1099 RICHARDS STREET (COMPLETE APPLICATION)
DE416775 - ZONE DD

DEVELOPMENT PERMIT STAFF COMMITTEE MEMBERS

DEVELOPMENT PERMIT STAFF COMMITTEE RECOMMENDATION: APPROVE

FOR BERWHL DEVELOPMENT LTD
 PARKING P3

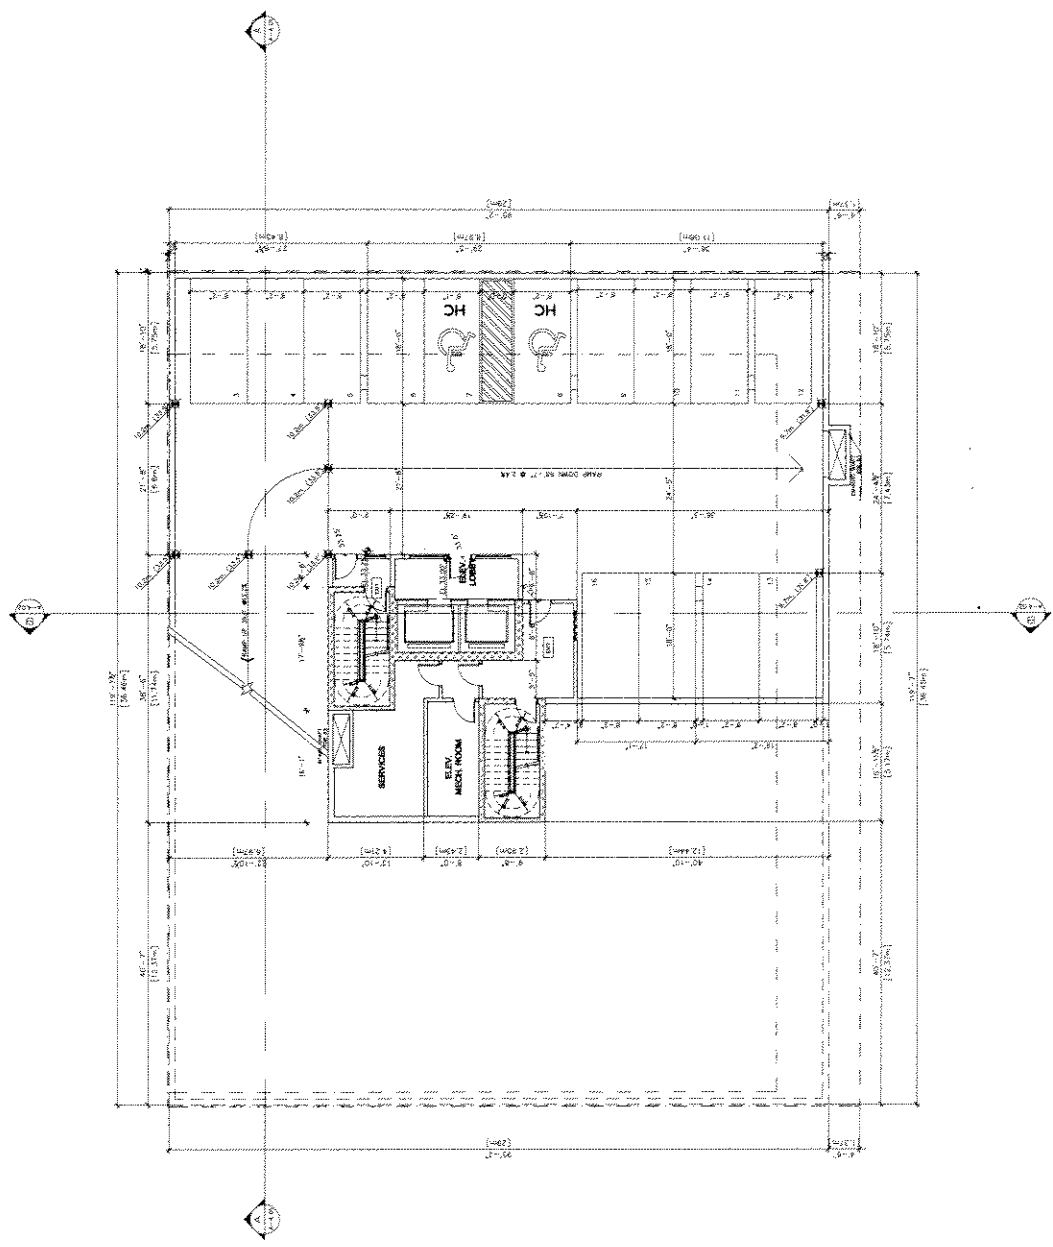
Note to Applicant: Refer to the Administrative Bulletin for design parameters in Appendix E. Due to the relative small size of many of these dwelling units staff anticipate that these storage units will need to be provided in the underground parking area.

GROUND LEVEL
FLOOR PLAN

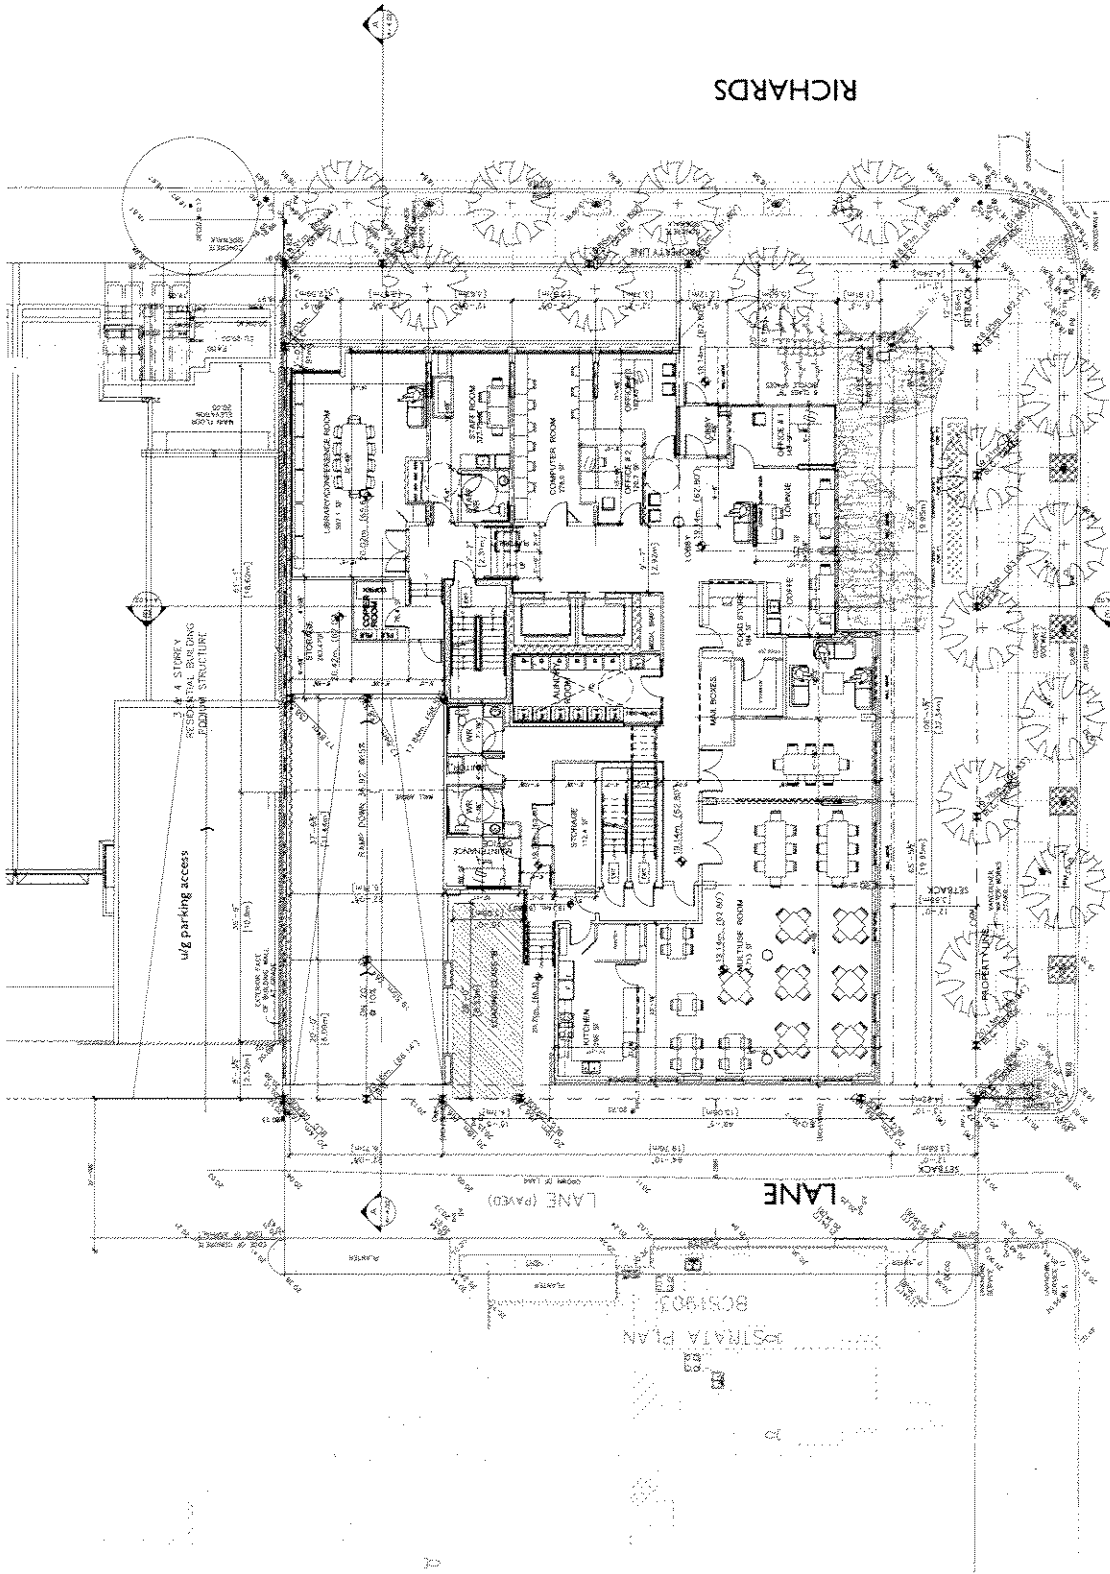
It is presumed with your consultation so far with B.C. Hydro that an area has been defined within the development footprint to accommodate such electrical plant. Please confirm that this space has been allocated and agreement between both parties has been met. At this time there seems to be no allocation of such plant shown on the detailed site plan A-2.01, A-2.02, A-2.03 and A-3.01.

ROOF LEVEL

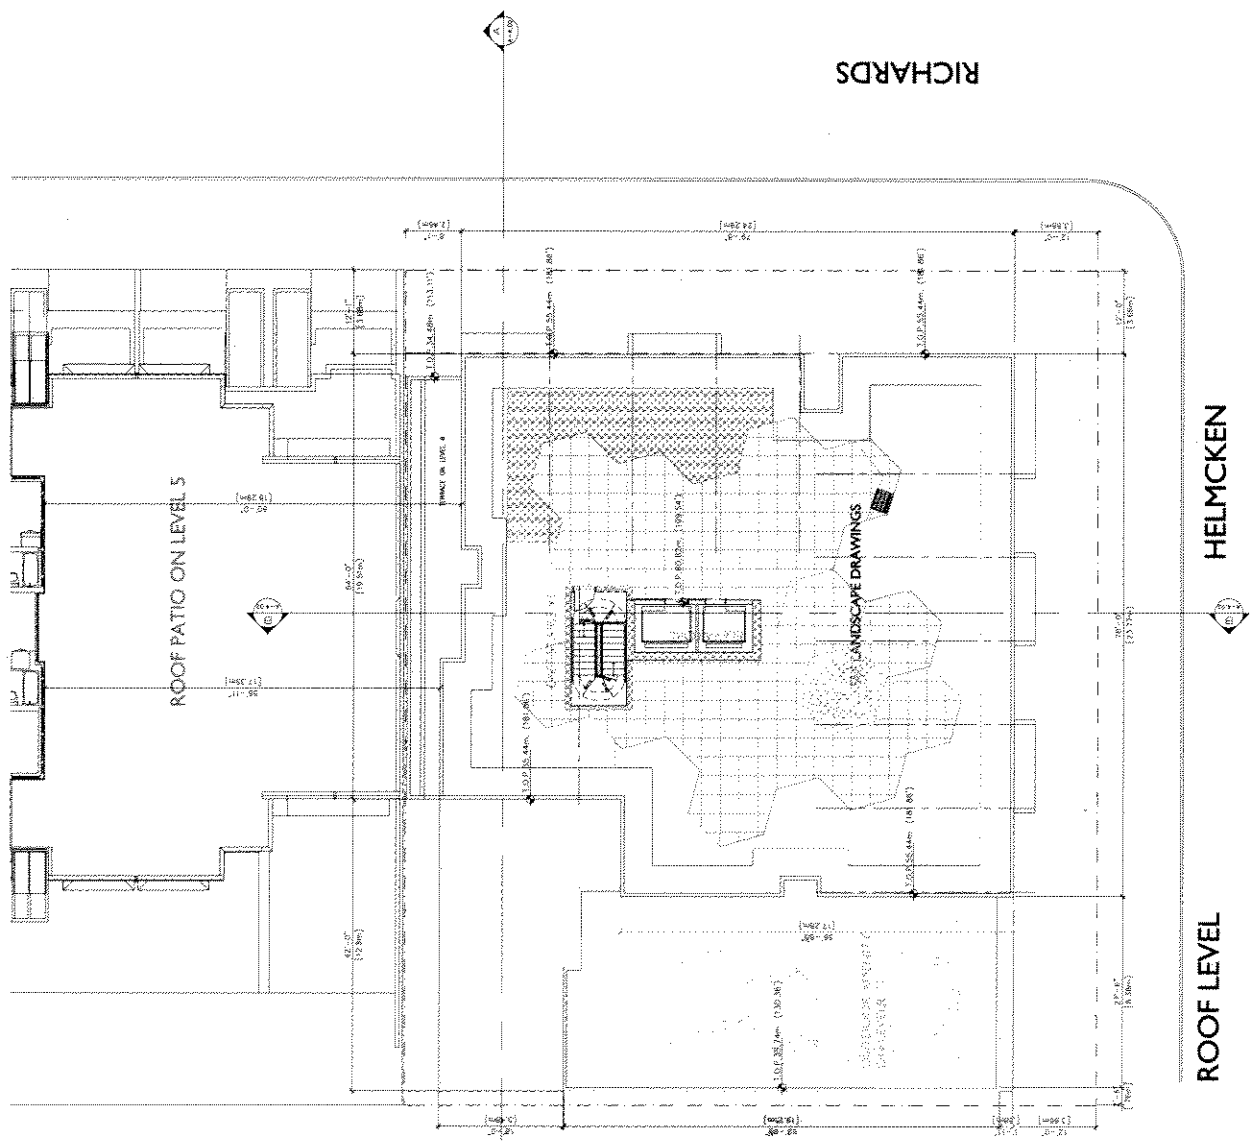
Note to Applicant: Show guardrail on roof level and roof plan with height elevation. Also add height elevation to sections. Add dimensions to roof garden accesses.
